ASHLAND PLANNING COMMISSION

**ASHLAND PLANNING DEPARTMENT
STAFF REPORT**

PLANNING ACTION: PA-T2-2024-00050
OWNER: Charlie Hamilton
APPLICANT: Rogue Planning & Development Services, LLC

PROPOSAL: A request for concurrent Outline and Final Plan approval for a four-lot Performance Standards Option (PSO) subdivision. The proposed subdivision includes three residential lots and one open space lot for the property located at 113 Pine Street. The application includes a request for an exception to street standards to not install standard street improvements due to the existing sidewalk. The application also includes a request to remove five significant trees.

PRELIMINARY SUBDIVISION
"MIDTOWN TERRACES"

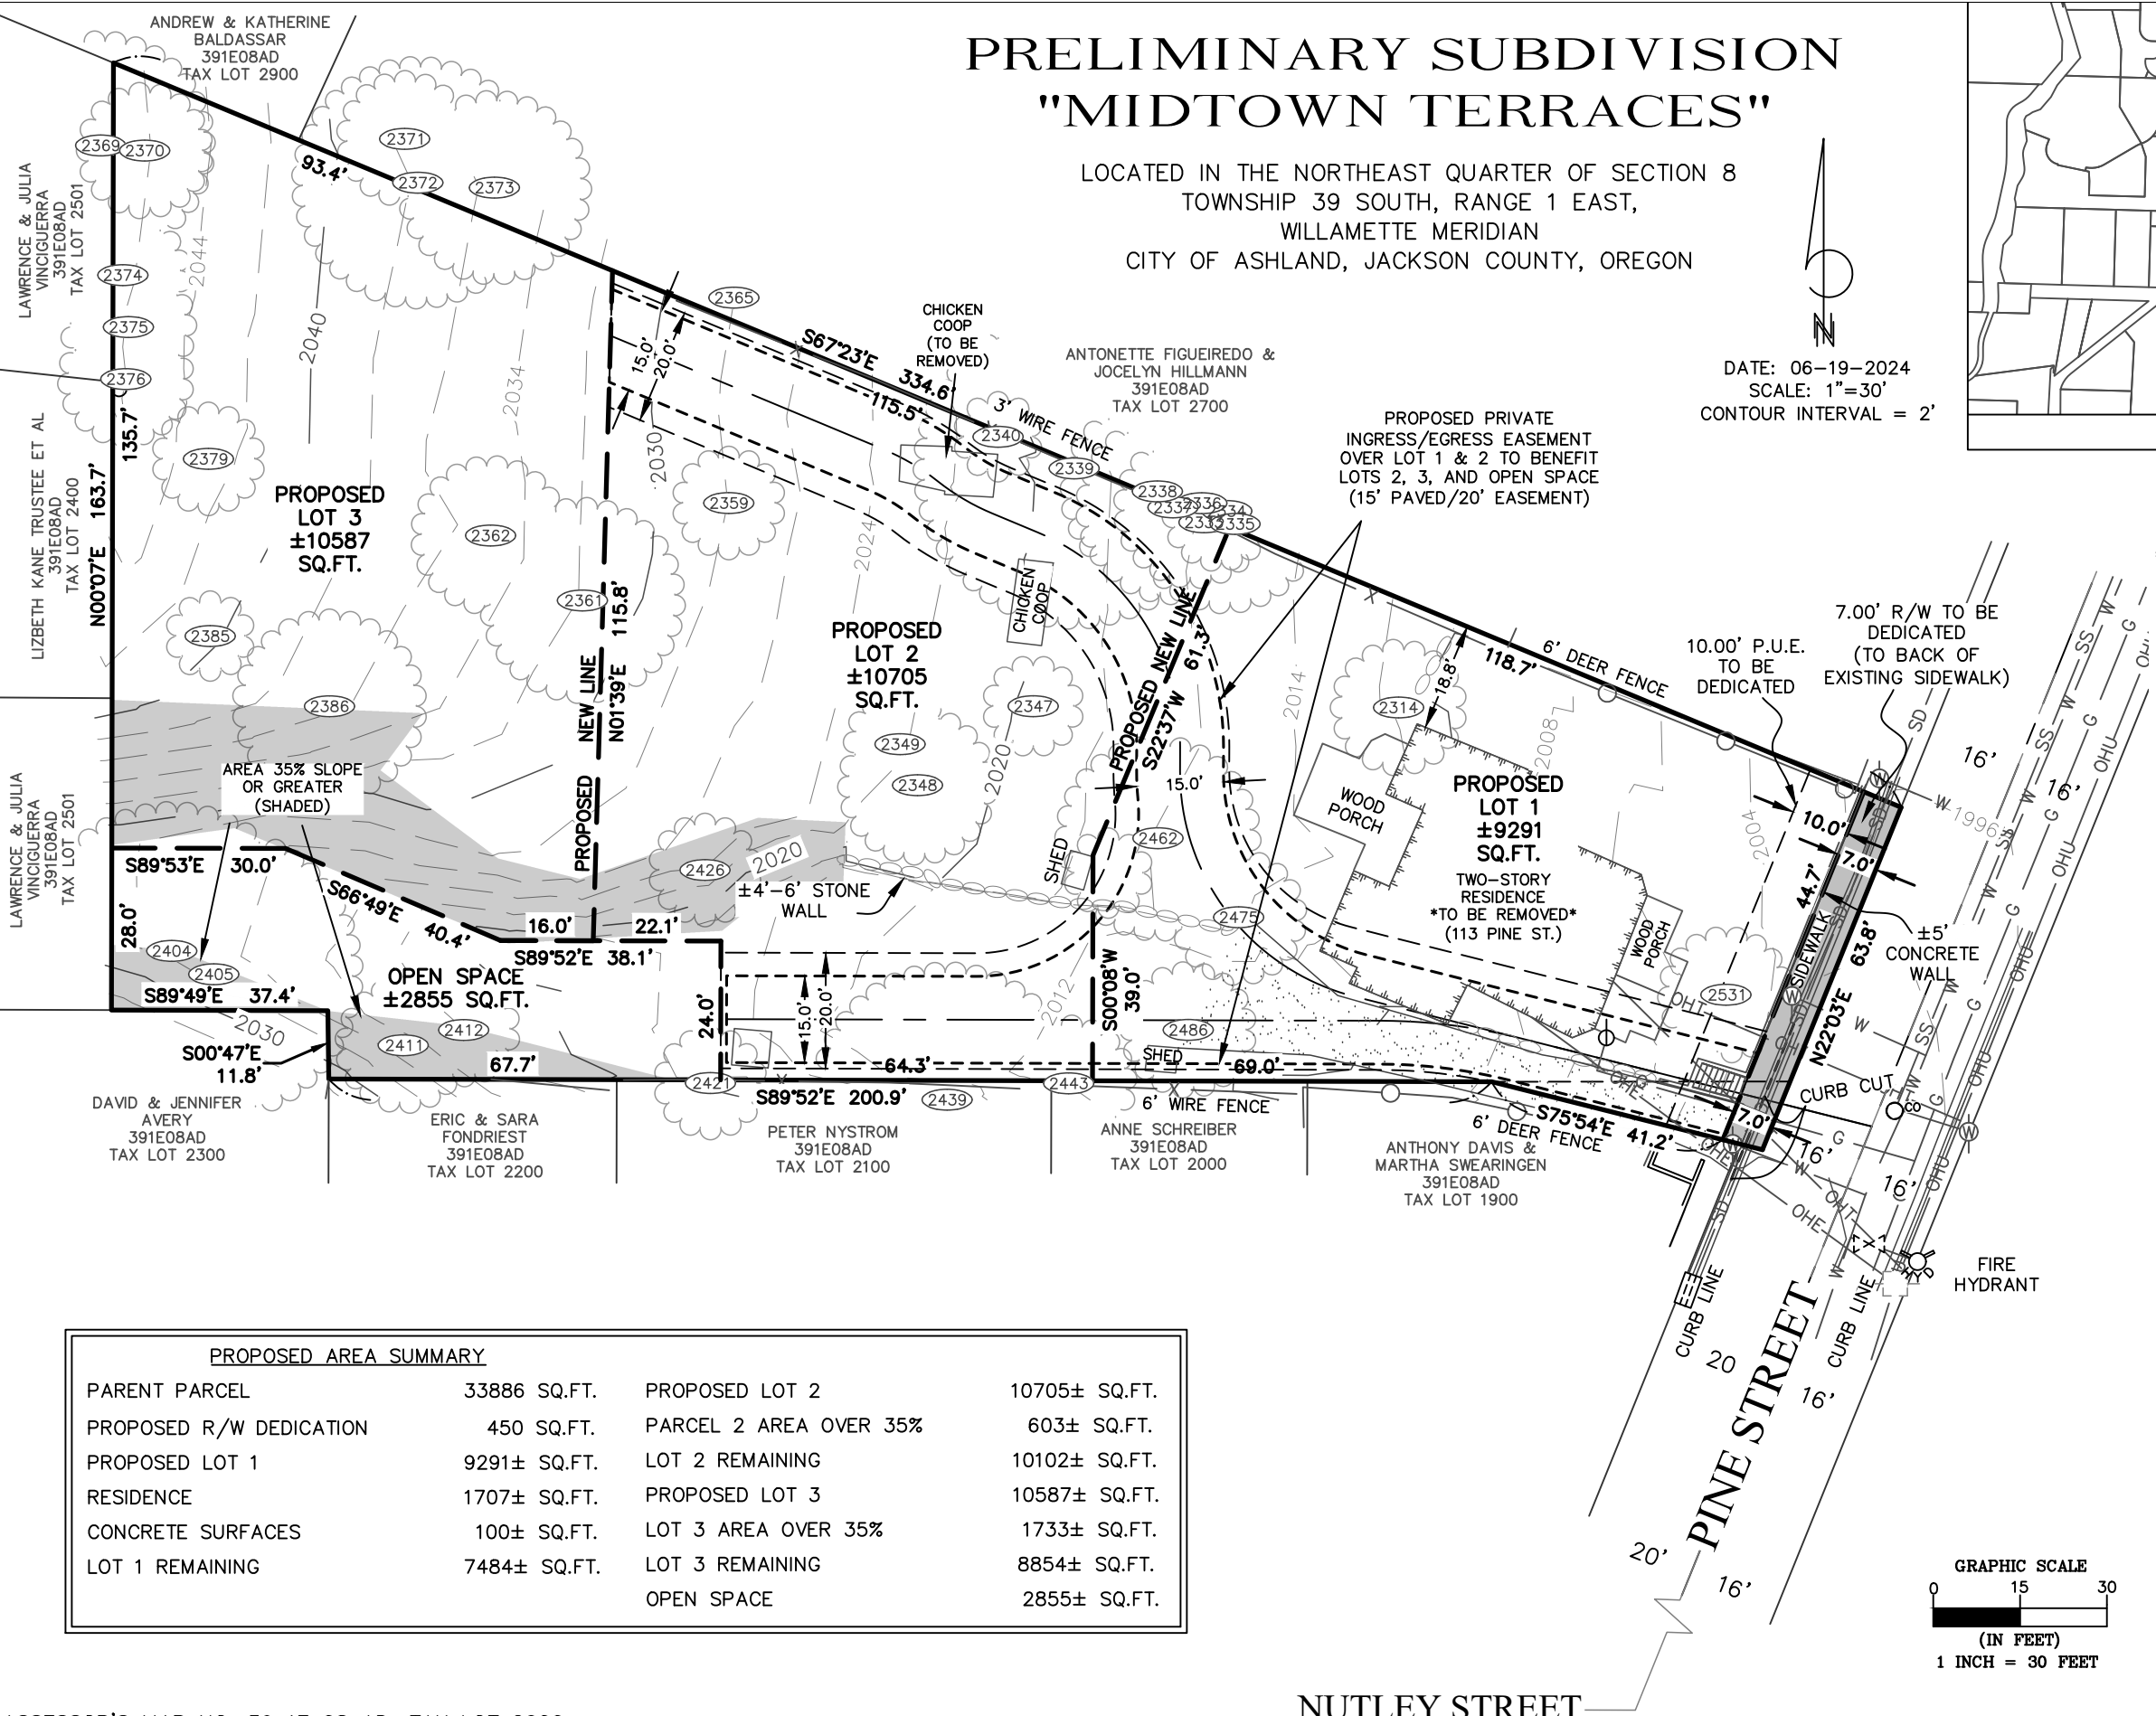
Also, though 27 trees are listed "to be retained" (see Page 41 of the Suncrest proposal), the site map on Page 46 shows that this is impossible, as a road is proposed over the site of several trees that are listed on Page 41. See for example Tree number 2486 as an example of a false claim that a tree will be retained when the site map clearly shows that the tree will be destroyed. Also listed on Page 41 of the proposal as "retained" is tree number 2379, listed as a healthy black oak, yet, this tree is shown as "planned for removal" on the map on Page 51. In fact, the map on Page 51 has several discrepancies with the list on Page 41 and the overall numbers cited in the proposal. I counted 19 trees designated for destruction on the map on Page 51, whereas the list on Page 41 gives the number of destroyed trees as 11.

It does not make sense to plan driveway space that runs around the bottom two lots and makes those lots prone to unnecessary traffic. The "common space" does nothing for anyone except to make the top lot more open and desirable -- there are no neighbor driveways taking up space.

I believe the driveway should be extended all the way up along the side of the development closest to Nutley St. Any easement should include maintenance requirements equally portioned to the three lots (even tho' as planned the top lot does not have as much asphalt around it). I think there should be some off street parking to accommodate visitors -- the current "common space" could provide two or three parking spaces that could be used equally by all lots. This additional space is important in addition to whatever turnaround and parking is planned for each lot. I also think the fire department access would be facilitated without the driveway extending across the property. I think the livability of the properties and the unique character of the neighborhood should take precedence over the most convenient or cheapest solution for development.

TREE PROTECTION PLAN LEGEND	
SYMBOL	DESCRIPTION
	TREE TO REMAIN (CANOPY APPROX. PER SURVEY)

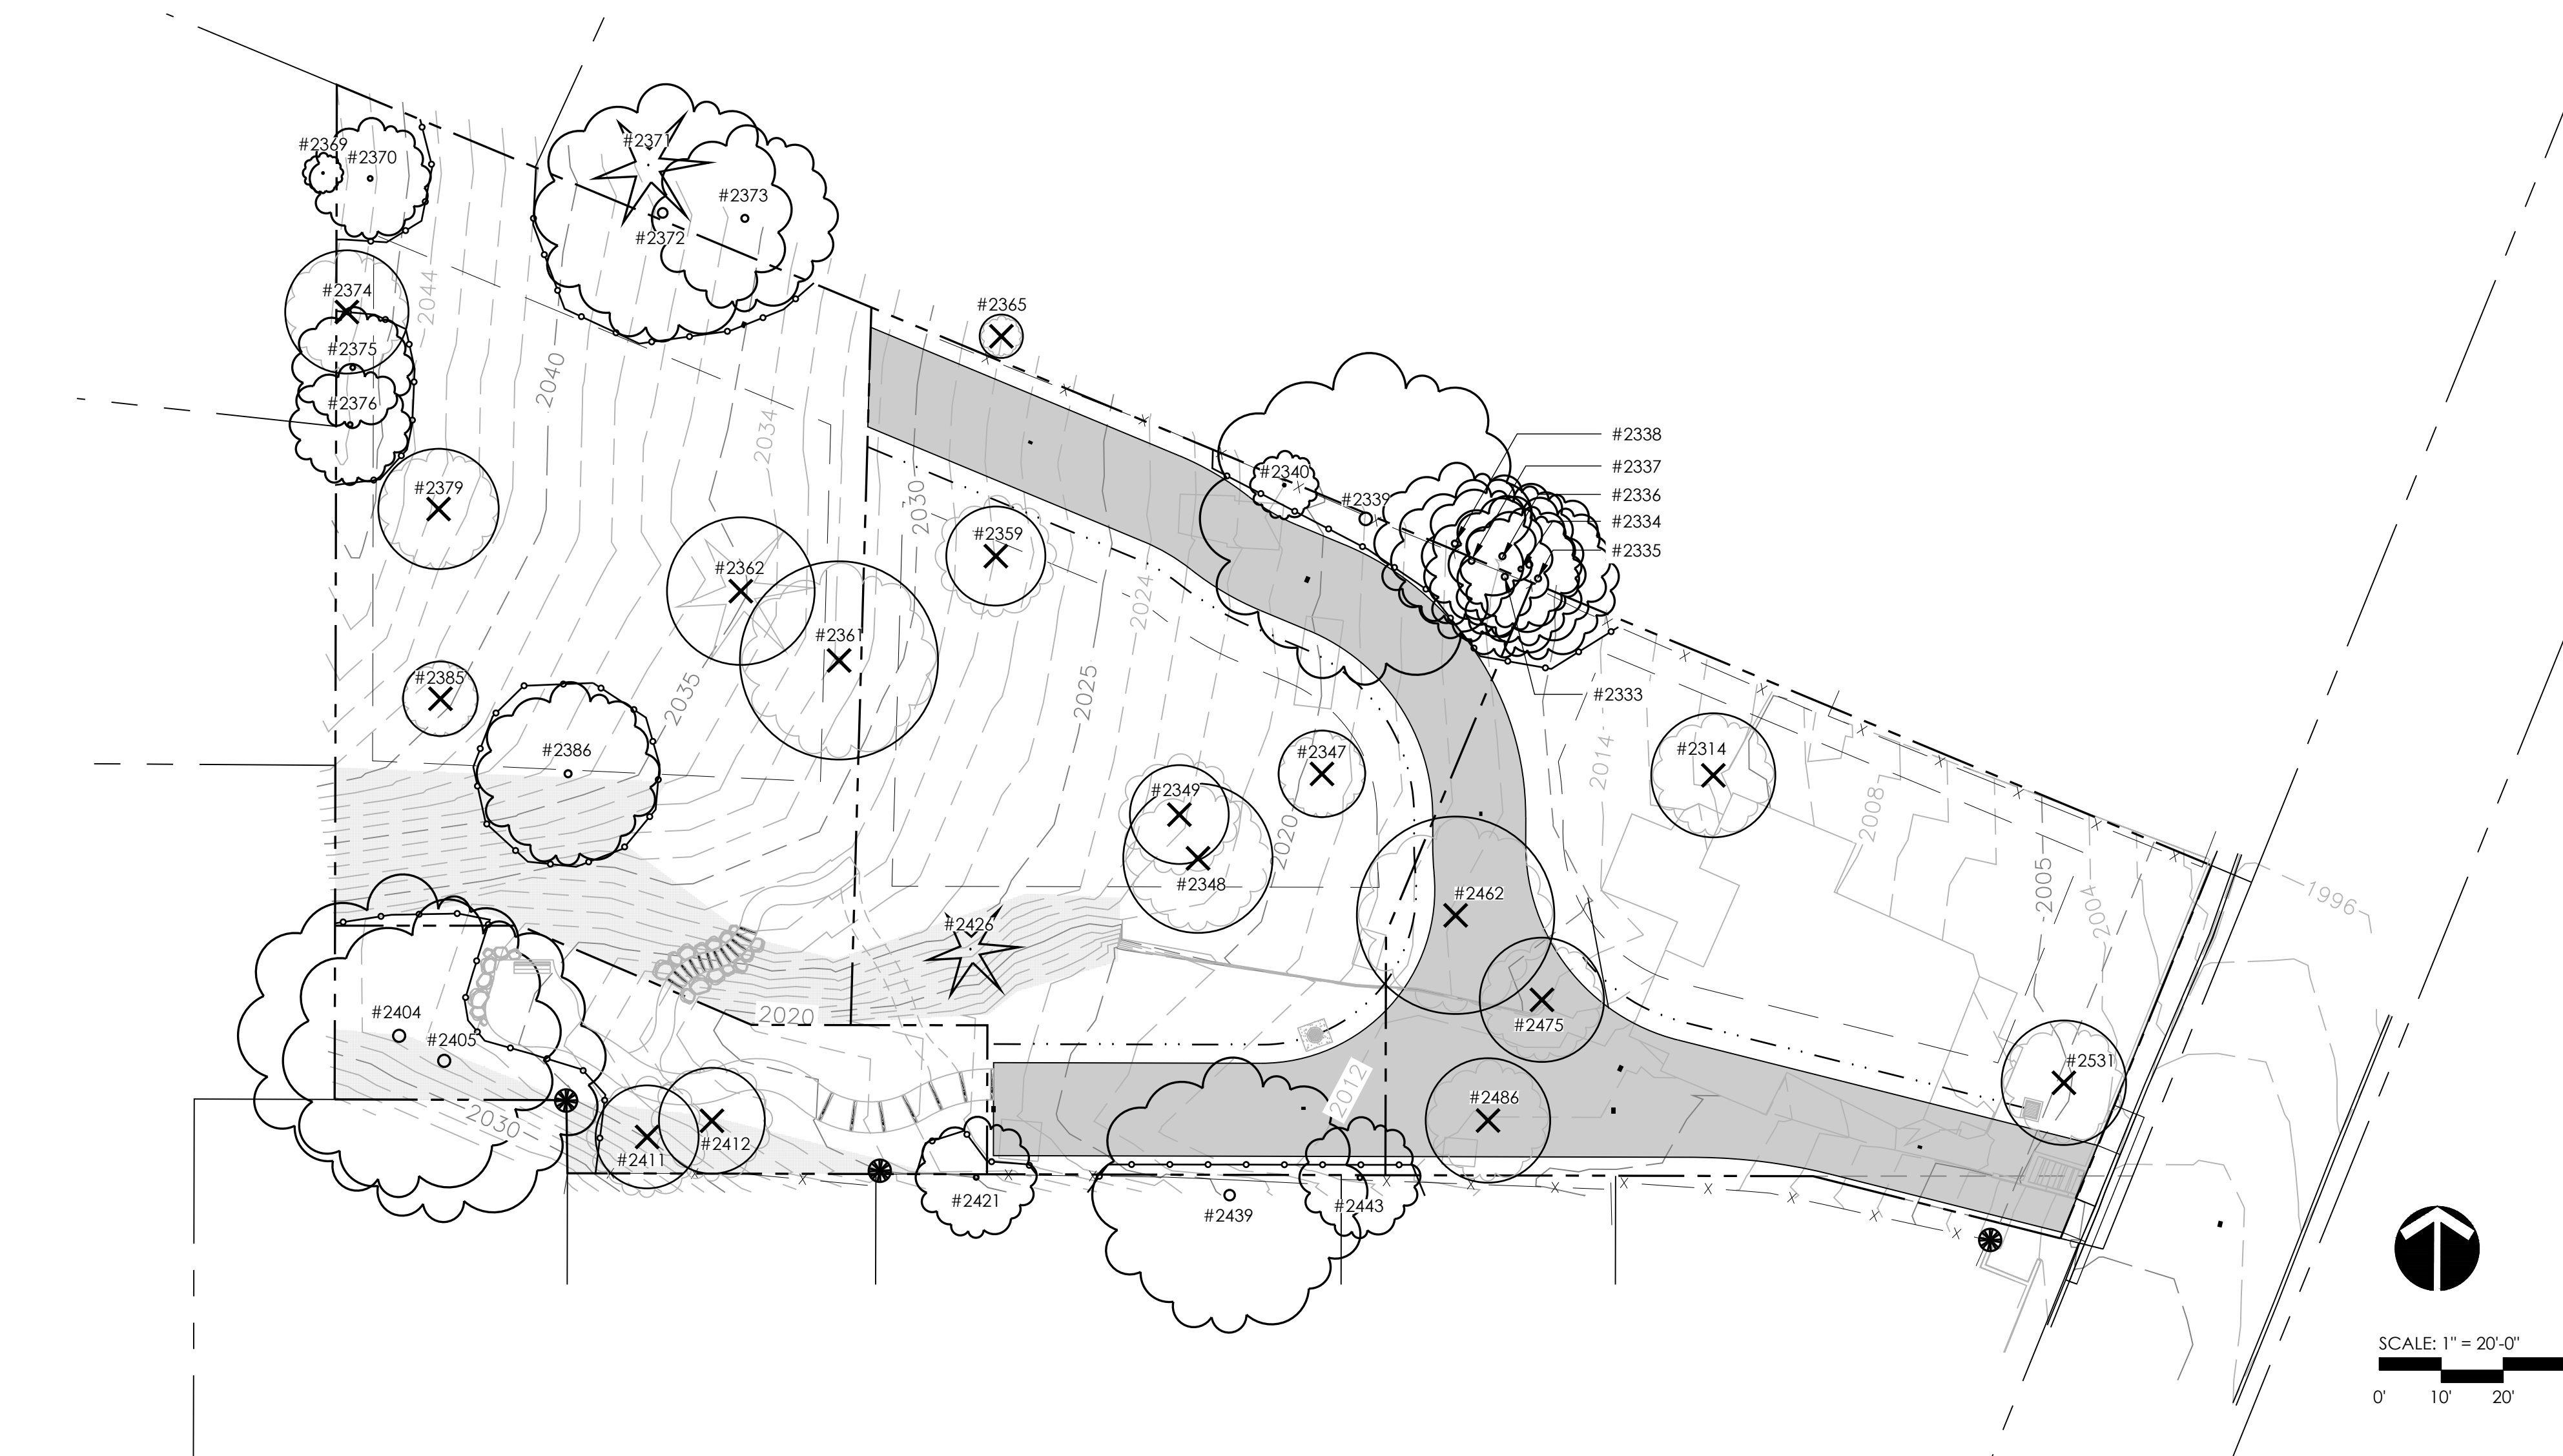
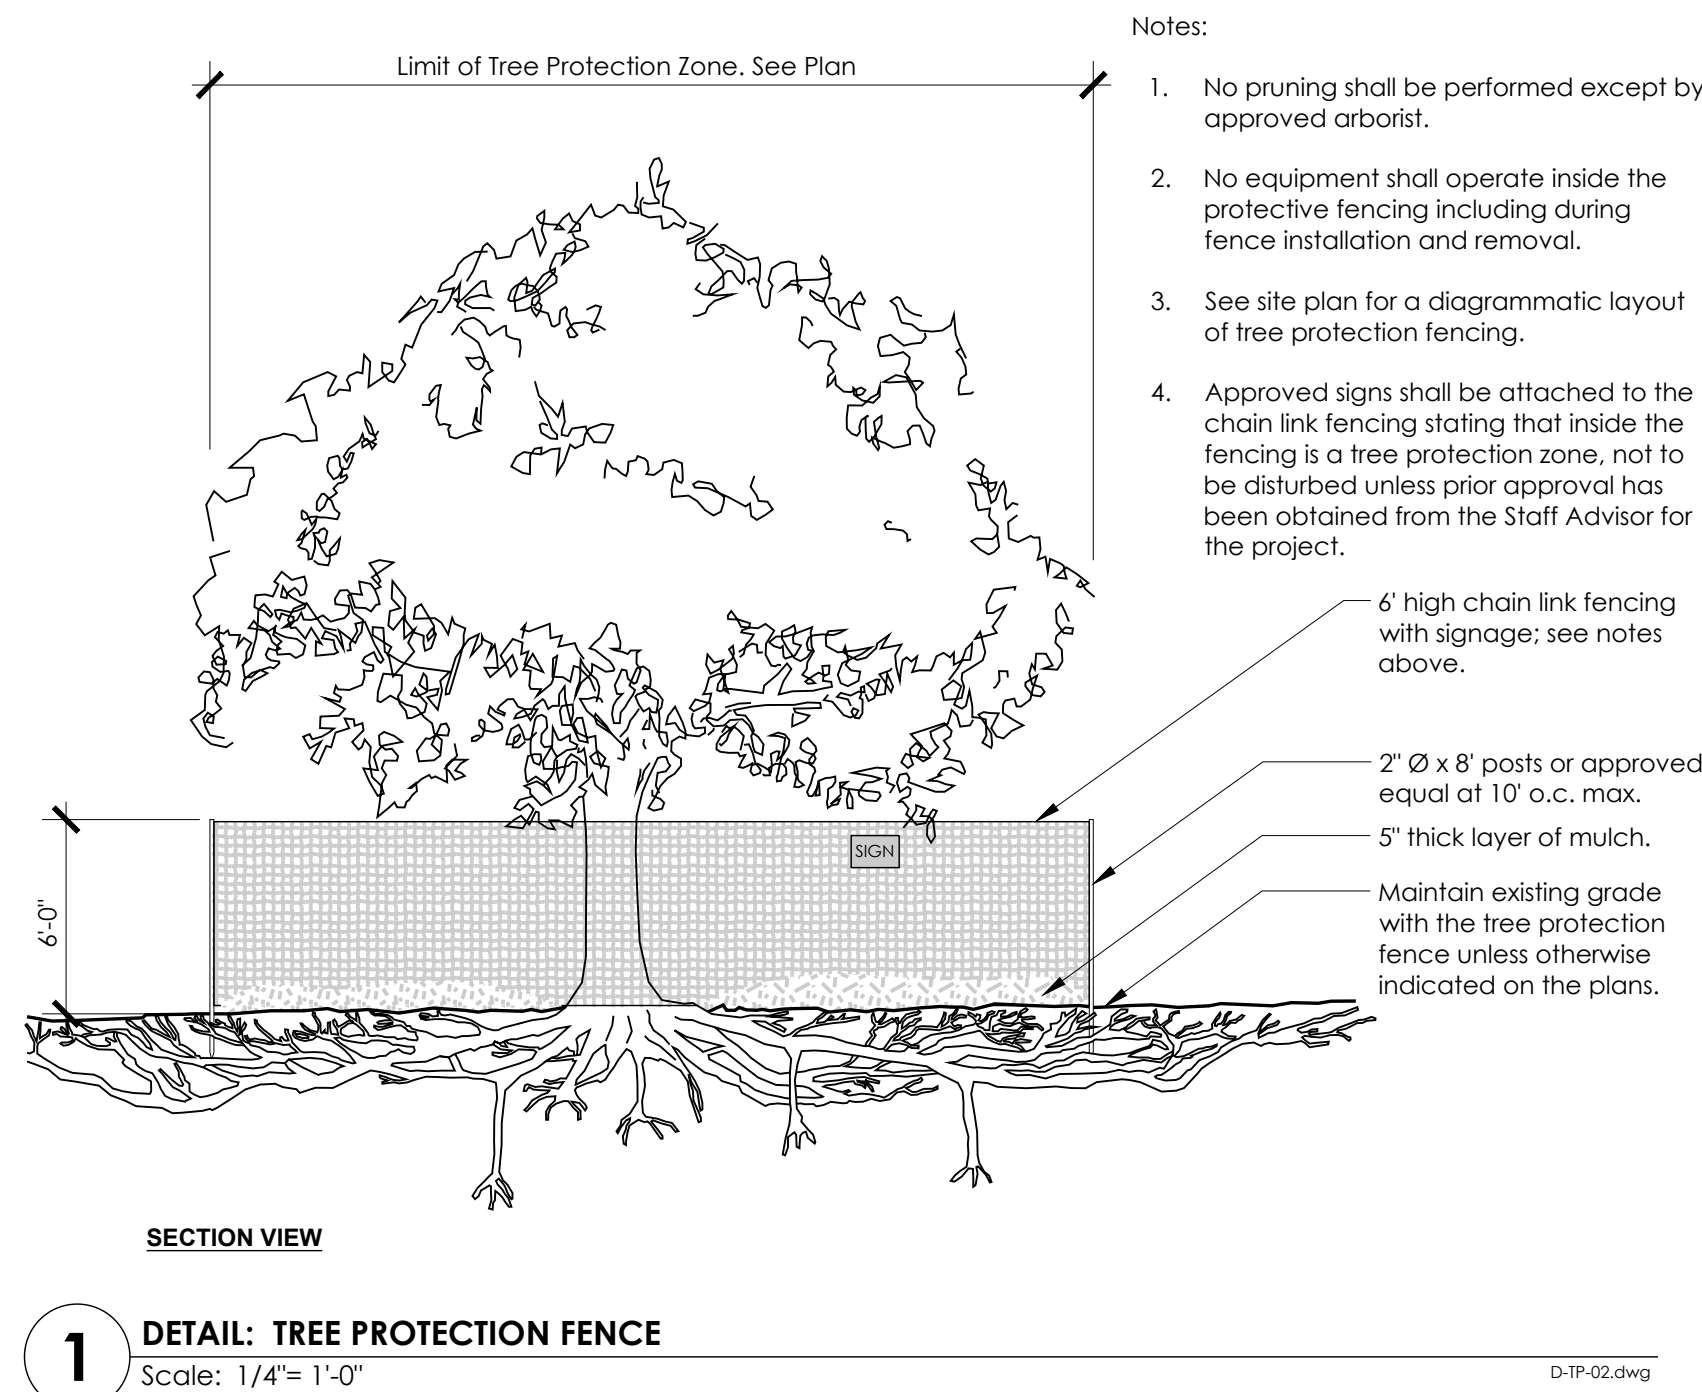
- 1) That all proposals of the applicant shall be conditions of approval unless otherwise specifically modified herein.
- 2) That the building envelope on lot three be modified to protect three healthy Oak Trees that are 6, 8, and 16 inches DBH (#2385, 2379, 2361 respectively) and that the revised plan be submitted prior to any site work.
